UNITED STATES PATENT AND TRADEMARK OFFICE

APPLICATION NO.	FILING DATE	FIRST NAMED INVENTOR	ATTORNEY DOCKET NO.	CONFIRMATION NO.
10/612,918	07/07/2003	Kelly F. Williams	91429MGB	6941

Office Action Summary

DETAILED ACTION

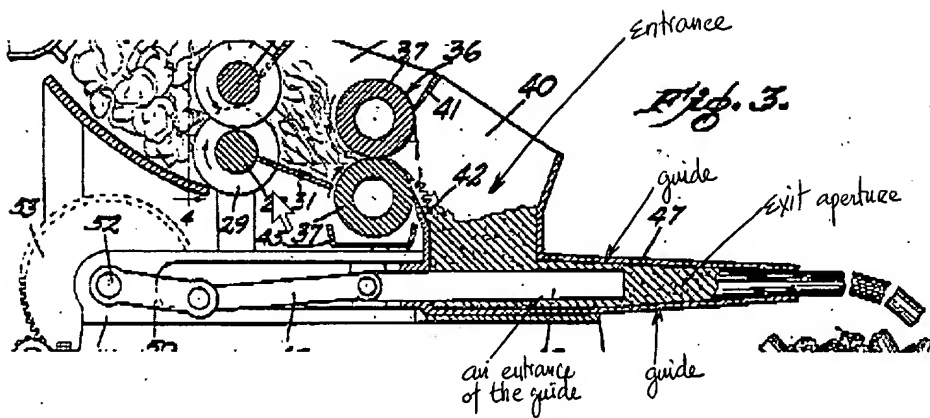
Claims 1-3, 14, 15, and 19 are rejected under 35 U.S.C. 102(b) as being anticipated by Paxton (US 1,819,480). The claims are rejected for substantially the same reasons as set forth in the last Office action. Those reasons are herein repeated.

Regarding claim 1, Paxton discloses a compactor comprising: an elongate compression chamber having an entrance and an exit aperture (see the illustration below); a pair of opposing input rollers (37) located at the entrance to the pre-compression chamber, at least one of the rollers provided with rotational drive (page 2, lines 12-14); a moveable plunger (48) operable to sweep a volume of the pre-compression chamber between the entrance and the exit. Note that the limitation “slipsheet” is not positively claimed and it is being claimed as an intended use. Paxton discloses the compactor as claimed as set forth above; therefore, the compactor is capable of compacting slipsheet.

Regarding claim 2, the pre-compression chamber has a transverse cross section that is inwardly tapered towards the exit aperture (see the illustration above).

Regarding claim 3, the pre-compression chamber comprises a pair of spaced apart guides defining a passageway having an entrance at one end thereof and defining the exit aperture at the other end thereof, the passageway inwardly tapered at least in a portion in proximity to the exit aperture (see illustration above).
